Takes of Marine Mammals Incidental to Specified Activities; Taking Marine Mammals Incidental to an Exploration Drilling Program in the Chukchi Sea, Alaska; Notice

ACTION: Notice; issuance of an incidental harassment authorization.

SUMMARY: In accordance with the Marine Mammal Protection Act (MMPA) regulations, notification is hereby given that NMFS has issued an Incidental Harassment Authorization (IHA) to Shell Gulf of Mexico Inc. (Shell) to take marine mammals, by harassment, incidental to offshore exploration drilling on Outer Continental Shelf (OCS) leases in the Chukchi Sea, Alaska.

Figure 1. Source levels in 1/3-octave bands for the drillship Discoverer and ice management surrogate vessel (the ice handler Maersk Rover).

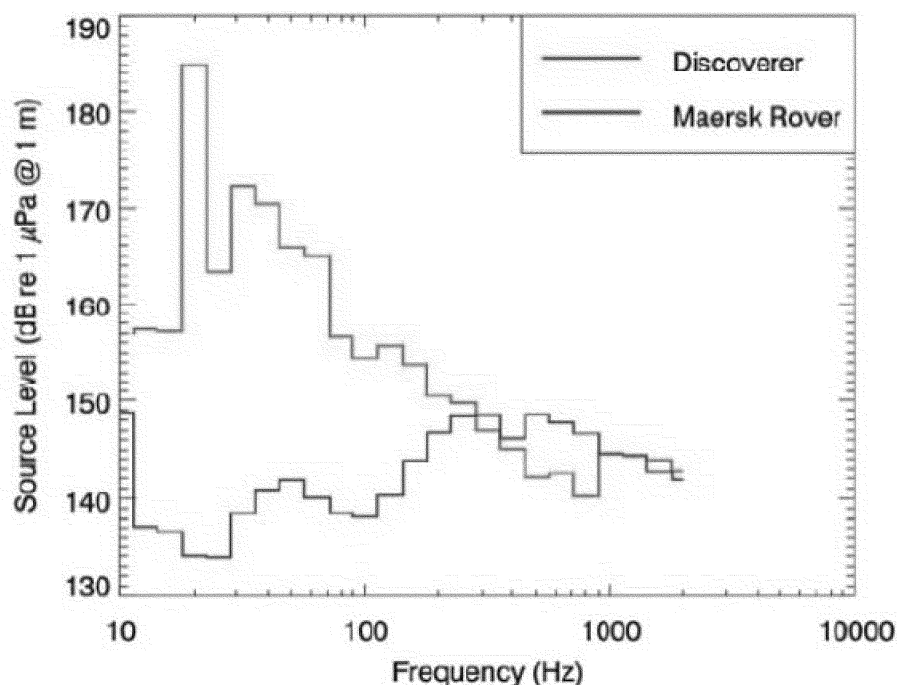
Comment 26: The MMC states that it is not clear which specific source level was used to model the size of the corrected 120-dB re 1 μ Pa harassment zone for the *Discoverer*, as the reported source levels for the *Discoverer* ranged from 177–185 re 1 μ Pa at 1 m. It also is not clear how the source level measurements taken in the South China Sea were incorporated in the model to estimate the 120-dB re 1 μ Pa harassment zone in the Chukchi Sea.

Response: The modeling analysis considered 1/3-octave band levels to account for frequency-dependent propagation effects that cannot

adequately be characterized with broadband analysis. The 1/3-octave band source levels were obtained from dedicated measurements of the *Frontier Discover* (now *Noble Discoverer*) during drilling activities in the South China Sea. A plot showing these levels is provided in the response to *Comment 27*, and the corresponding broadband levels could be computed by summing those if required. The modeling approach applied by JASCO Applied Science was the MONM parabolic equation acoustic propagation model in each 1/3-octave band from 10 Hz to 2 kHz. The resulting received band levels were summed to compute the broadband received levels at many depths, distances and directions from the planned drillship location. Representative sound level threshold radii were determined by calculating the 95th percentile distance, over all azimuths, at which the maximum threshold over all depths was received. This approach considers that animals may sample multiple depths as they pass by the drilling operation.

Figure 2. Temperature, salinity, and sound speed profiles at the Burger prospect obtained from the GDEM database for October.

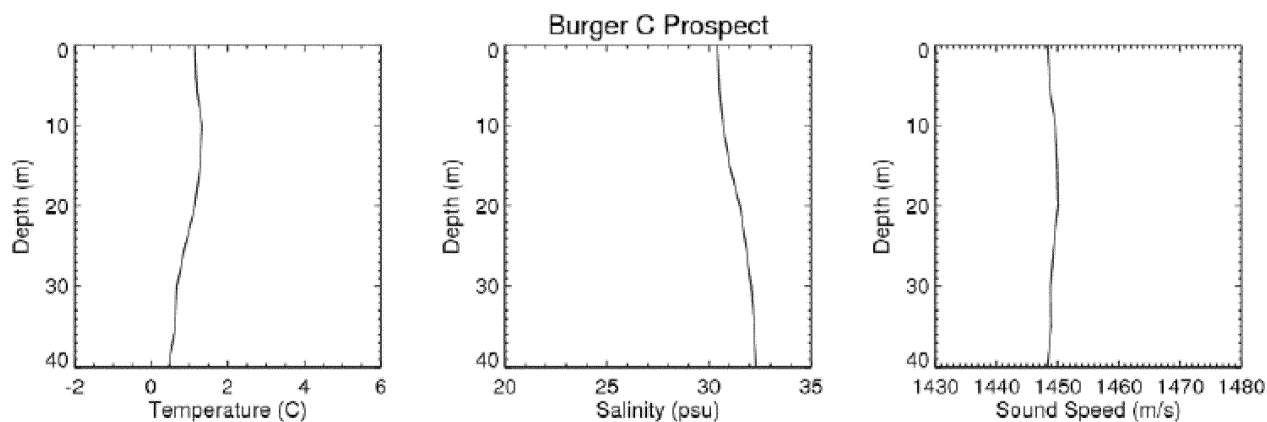
Comment 29: Dr. Bain states that the correction factor of 1.5 applied to the distance to the 120 dB contour is inadequate to conservatively account for the variability.

Response: The concern raised here is that the sound speed profile used for acoustic modeling of drill rig noise may not account for changes to the salinity and temperature profile that could influence and create variability in sound propagation, and the resulting variability might lead to conditions in which model estimates would not be conservative. The location-specific sound speed profiles considered for this modeling study were obtained from the GDEM database for conditions in July and October. A modeling study (Johnston *et al.*, 2009) investigated the difference in sound propagation for both months and showed longer-range sound propagation using the October profile. To be precautionary and to avoid underestimating the propagation, the modeling at the Burger prospect that was used for marine mammal effects assessment was conducted using the October profile (see Figure 2). Therefore, a correction factor of 1.5 is appropriate in this circumstance.

Figure 3. Band levels for the Kulluk during drilling.

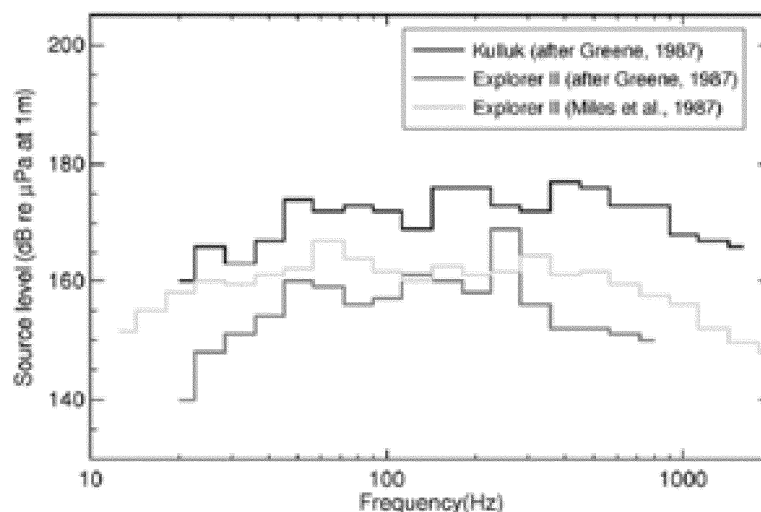
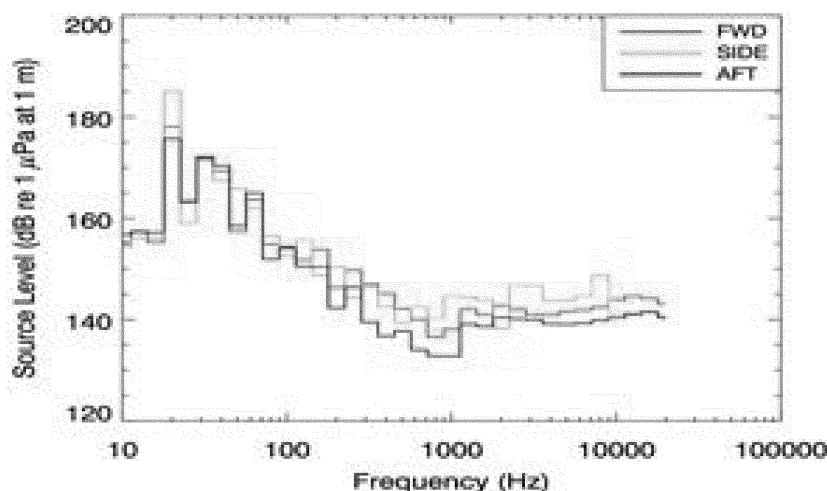
Comment 37: The NSB and AWL note that the modeled 120-dB isopleths for the *Discoverer* are different in the Beaufort and Chukchi Seas (with the isopleth being slightly smaller in the Chukchi Sea). Additionally, they question if the 120-dB isopleth for the *Discoverer* is correct given its nearly identical source level to the *Kulluk* drill rig (proposed for use in the Beaufort Sea), for which sound propagates out to the 120-dB isopleth at a much farther distance. If the modeled propagation is incorrect for the *Discoverer*, then this would bias the take estimates low.

Response: The primary reason for the difference in the distance of the 120-dB isopleths for the *Discoverer* in the Beaufort Sea vs. the Chukchi Sea is due to differences in the geoacoustic parameters for the two seas that were input to the model. Water depth, seabed density, and seabed sound speed are generally the most important parameters that influence sound propagation.

Differences in sound propagation from the two rigs are real and are caused by differences in the design of the two vessels. While the broadband source levels for the *Discoverer* and *Kulluk* may be similar, their spectral properties differ considerably. Acoustic modeling considers the source levels in 1/3-octave frequency bands. Figures 3 and 4 show the band levels for both drillships during drilling. Of key importance are the significantly lower levels of the *Discoverer* in the 50 to 500 Hz bands that propagate well in the relatively shallow waters of these drilling operations. While the *Discoverer* apparently has higher band levels below 50 Hz, this energy is more rapidly attenuated than higher frequency sound energy. This characteristic of sound propagation in shallow waters leads to predominantly mid-frequency sounds (50–500 Hz) dominating the acoustic field at distance from the drillships. A further consideration is that the *Kulluk* source levels are known to include contributions from support vessels, and much of the mid-high frequency band
